**SAN ANTONIO WATER SYSTEM**  
**Interdepartment Correspondence Sheet**

**Subject:** Zoning Case Z2020-10700230 (Tradesman Warehouse Development)

**Date:** August 30, 2021

ZONING FILE: QUARRY RUN WAREHOUSE (FIGURE 1)  
ZONING CASE: Z2020-10700230  
MAP PAGE: 169, A1

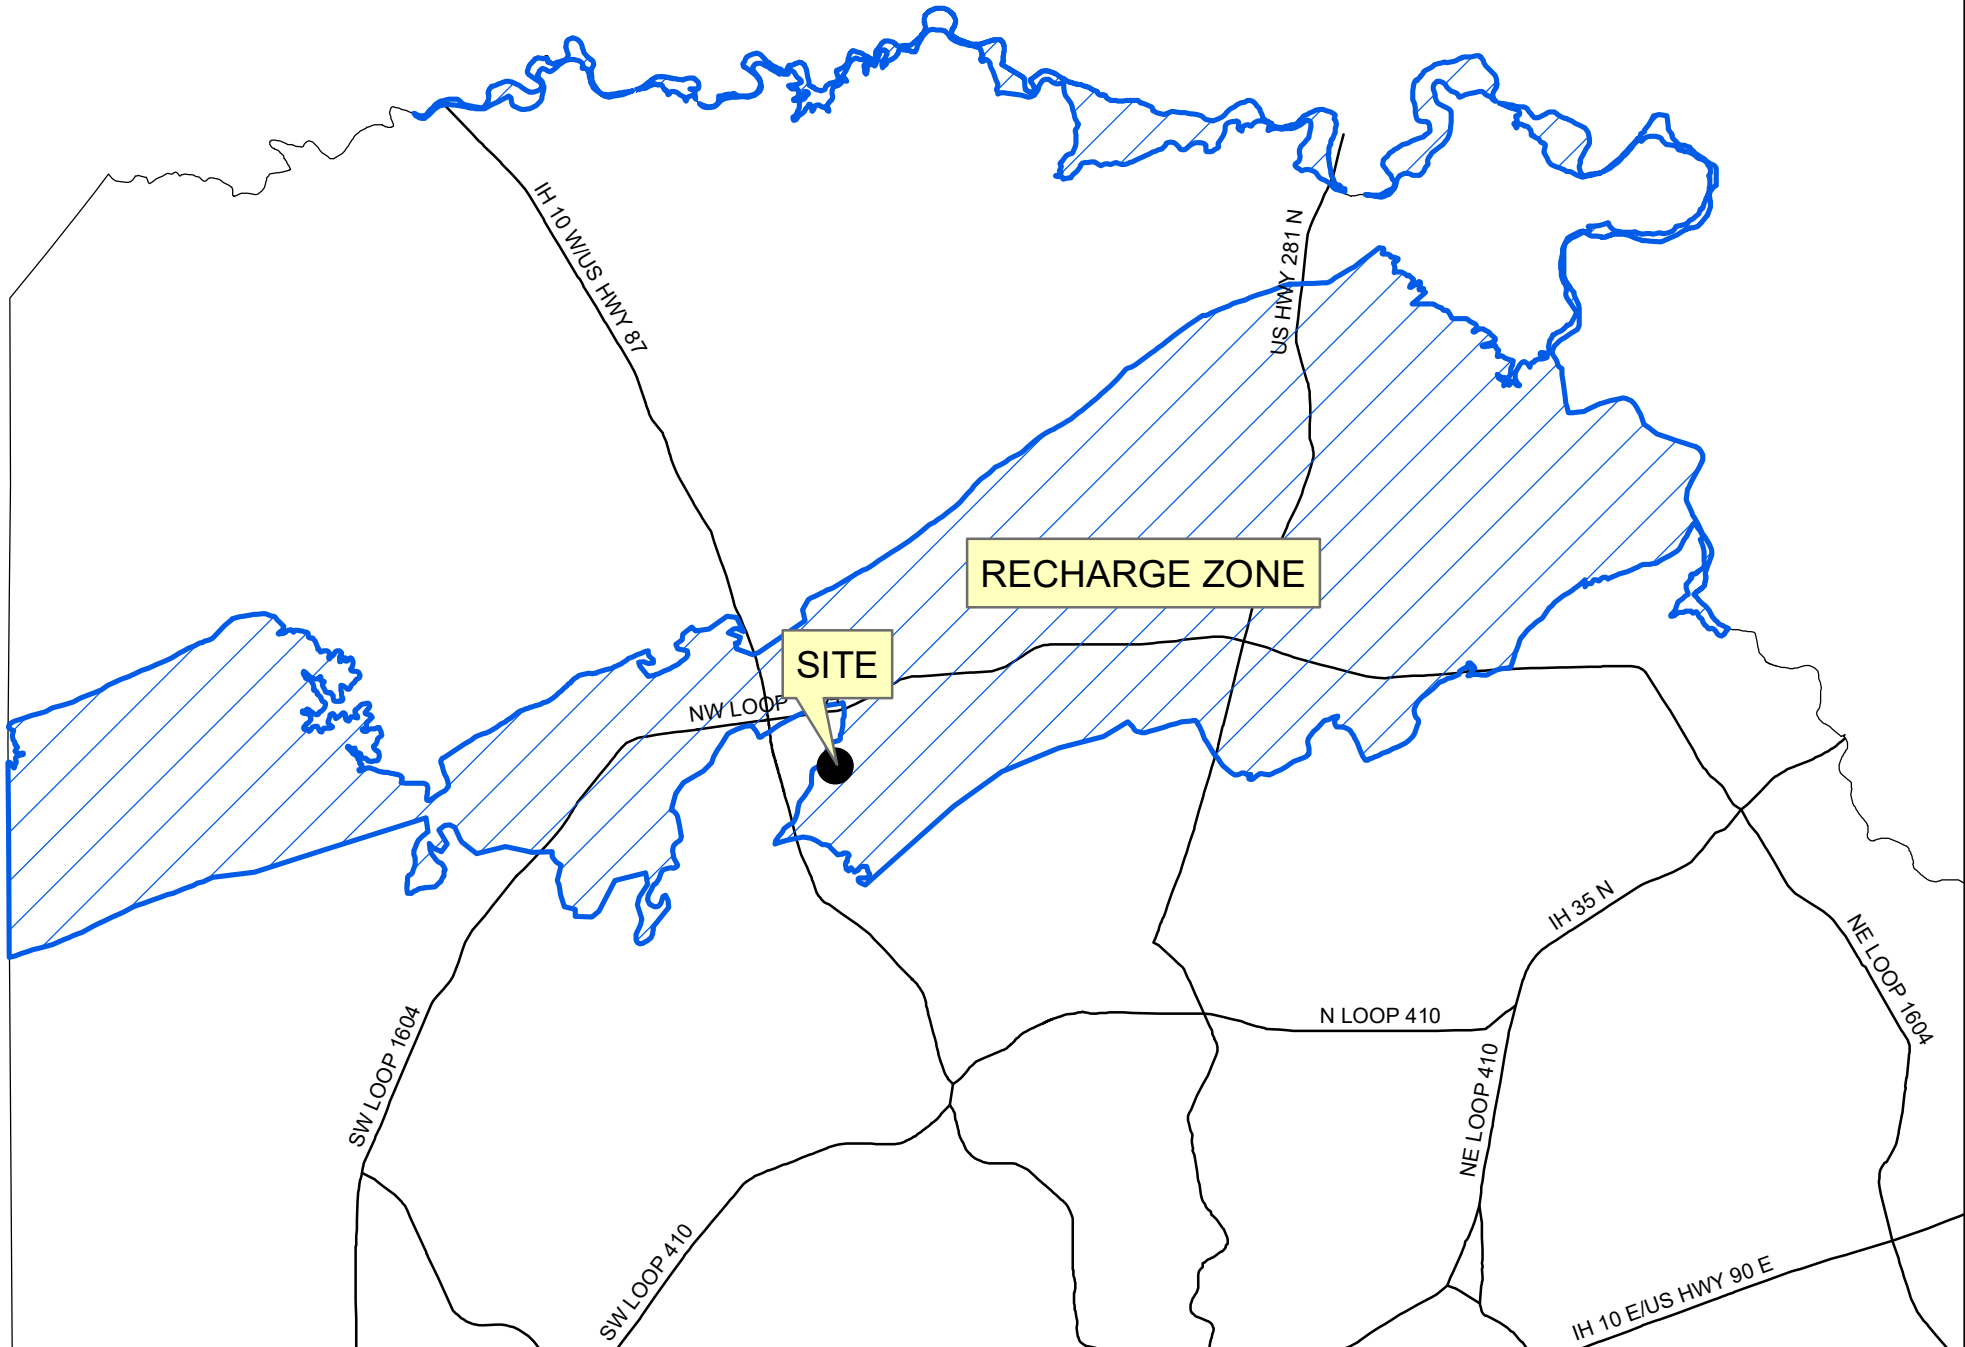
The subject property is in City Council District 8, located 650 feet south of the intersection of Tradesman Drive and Quarry Run Road. The property lies within the Edwards Aquifer Recharge Zone (Figures 1 and 2).

1. The 100-year floodplain lies along the western and southwestern portion of the property, where recharge may occur.

1. The impervious cover shall not exceed 48% on the 92.50-acre site.
2. No outside storage of chemicals/merchandise shall be allowed.
3. No manufacturing of goods/products.
4. No vehicle and machinery equipment maintenance nor repairs shall be allowed on site.
5. A floodplain buffer shall be provided along the western and southwestern portion of the property as required in Ordinance No. 81491, Section 34-913.
6. The land uses within the project site shall be in conformance with the table of permitted uses at the time the re-zoning is approved. Should a proposed use be listed as requiring City Council approval, the owner/operator shall apply for re-zoning for that particular use at the project site. If the land use is listed as special use, a special permit must be obtained for that use. If the land use is listed as not allowed, that land use will not be permitted on the project site.
